Re: Proposed Townhomes at Woodbank 0 Warburton Avenue

As the Architect representing PTG Development, LLC, owner of 0 Warburton Avenue, I am submitting the attached revised drawings, dated May 4, 2017, describing six new townhouses at 0 Warburton Avenue, for site plan, view preservation, and steep slopes review. Our submission consists of the following drawings:

In response to comments made by the Planning Board at the meeting on March 16, 2017, the drawings were revised, and additional drawings were prepared, as follows:

Prawing Trite
SITE PLAN

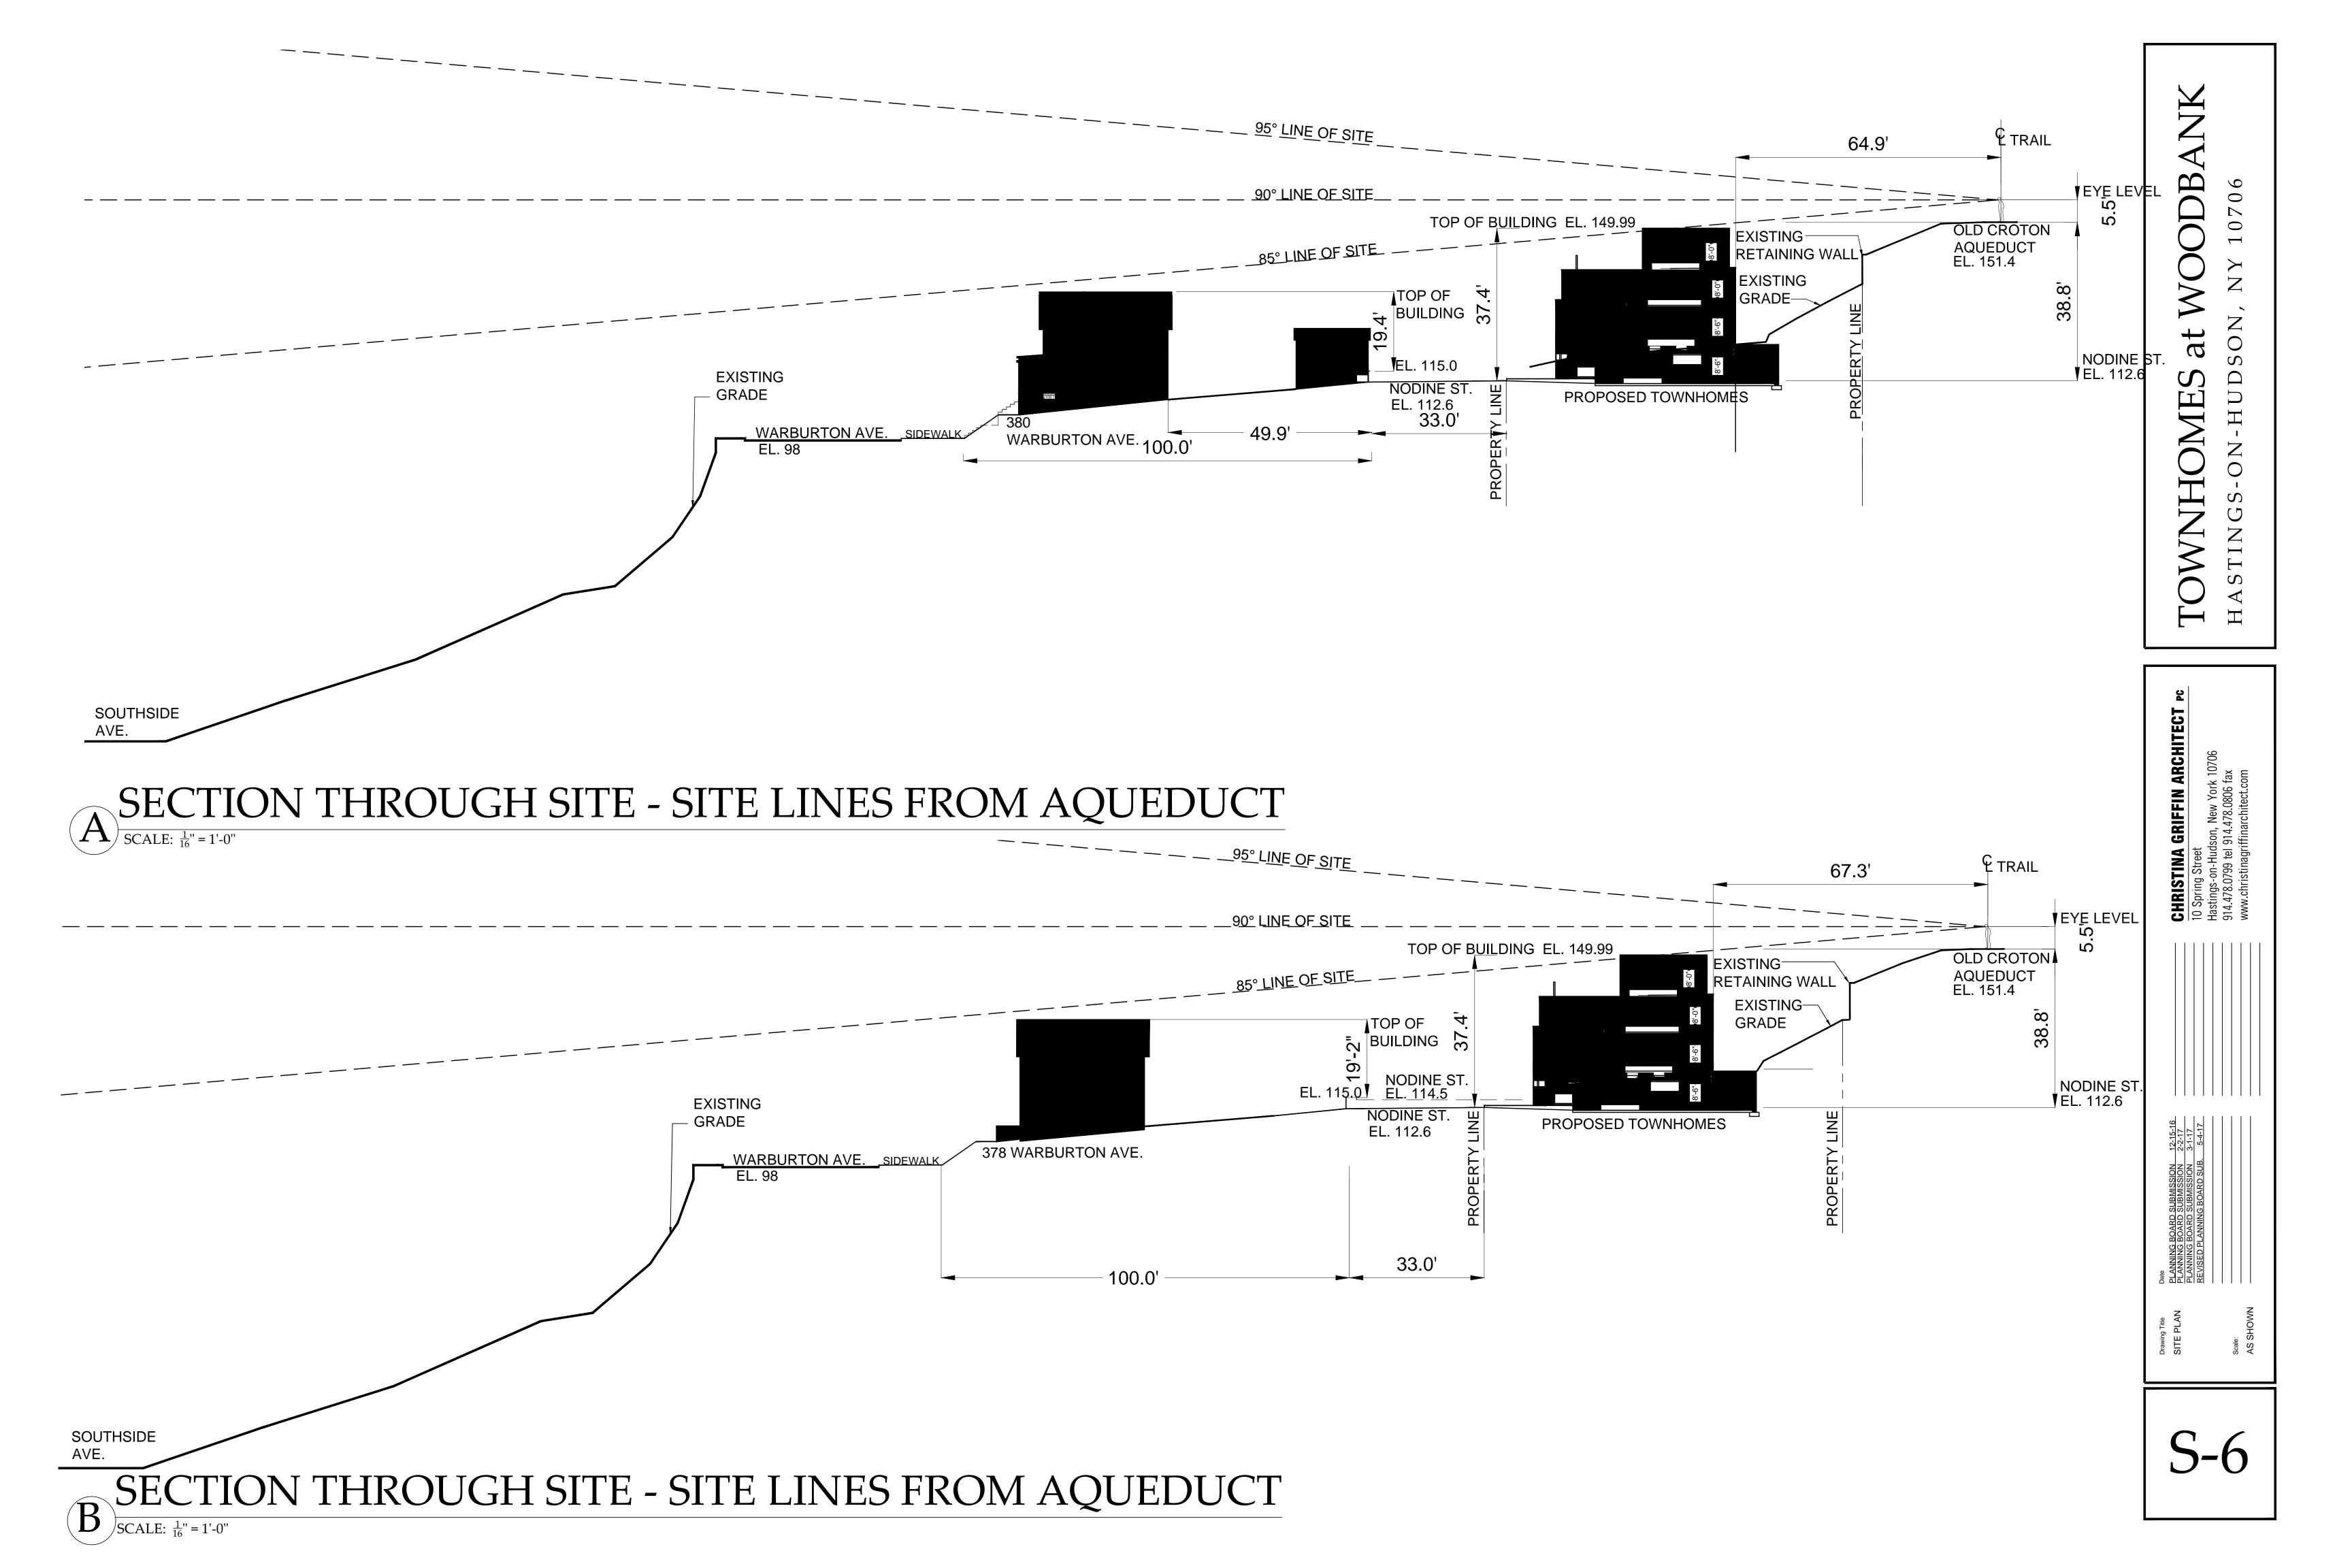
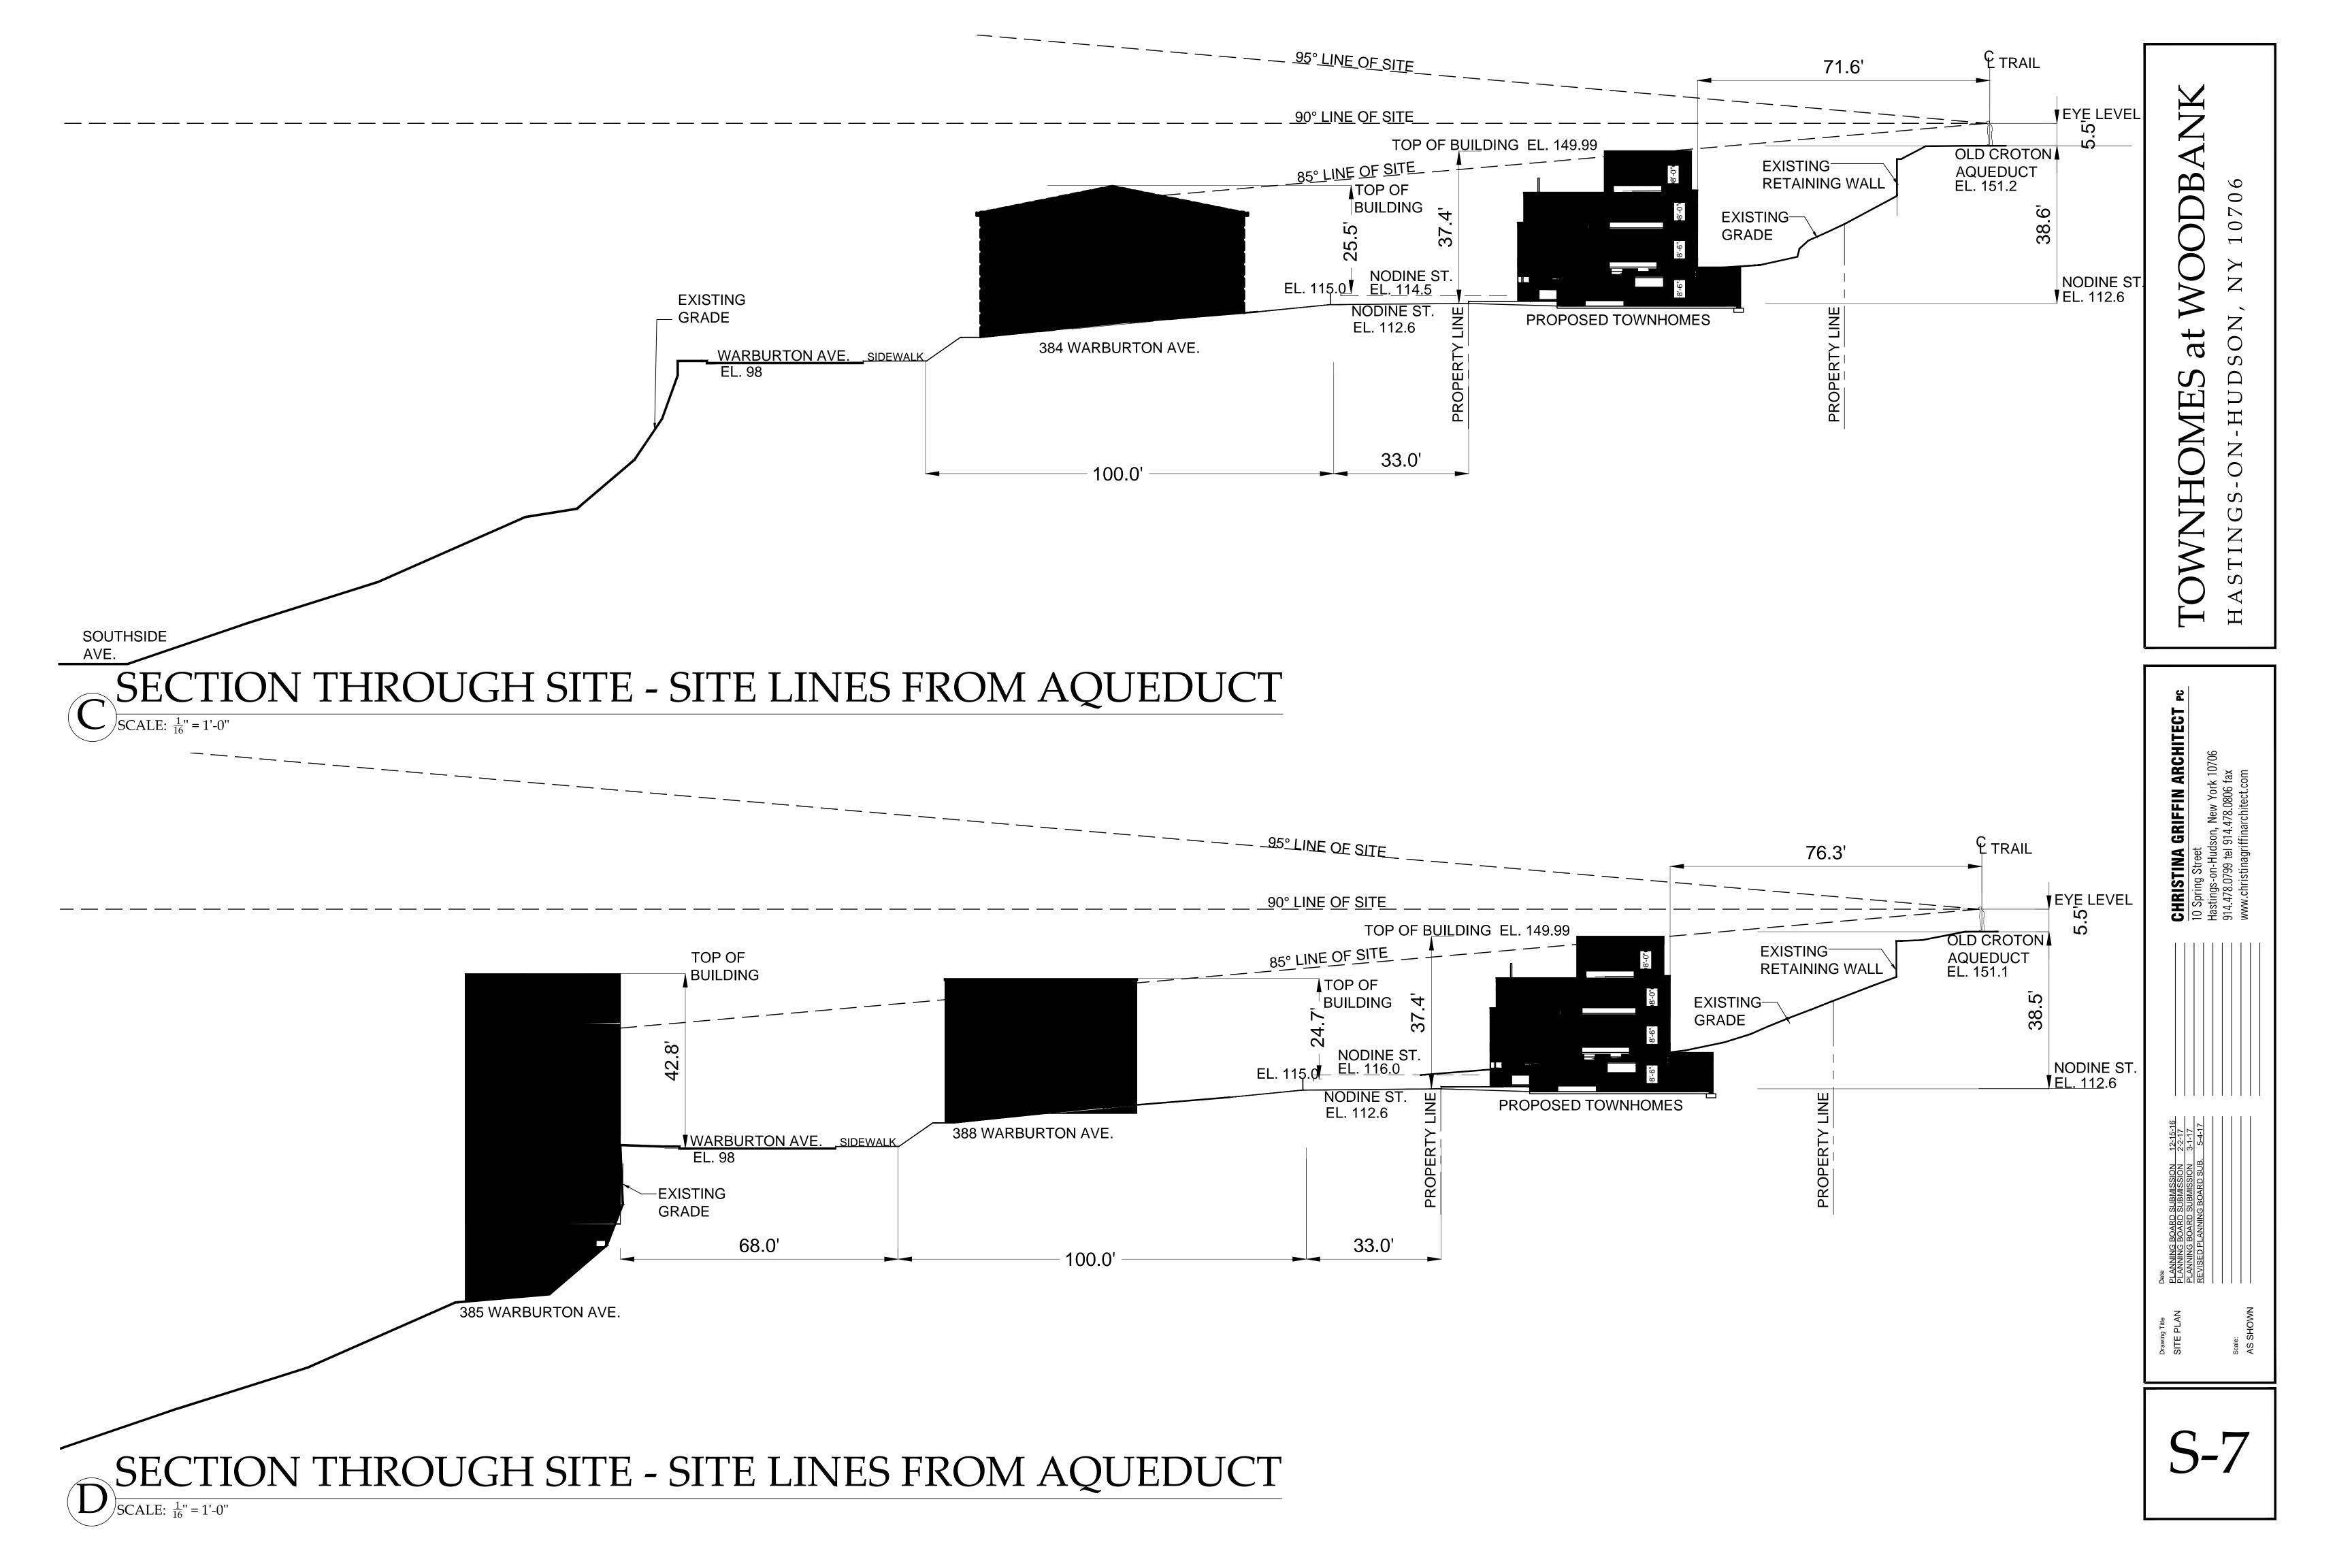
- 2. The development coverage has been reduced to 37% from 46%, as a result of lowering the building so that the garage is below grade, and eliminating the roof decks at the rear vard. The street elevation has been established at elevation 112.6, and as a result, we were able to lower the first-floor level. This street elevation will facilitate the design of a storm water drainage system, since the 112.6 elevation is a low point of the street, and allow the retaining walls of neighboring properties to remain. See Site Plan, Drawing S-2.
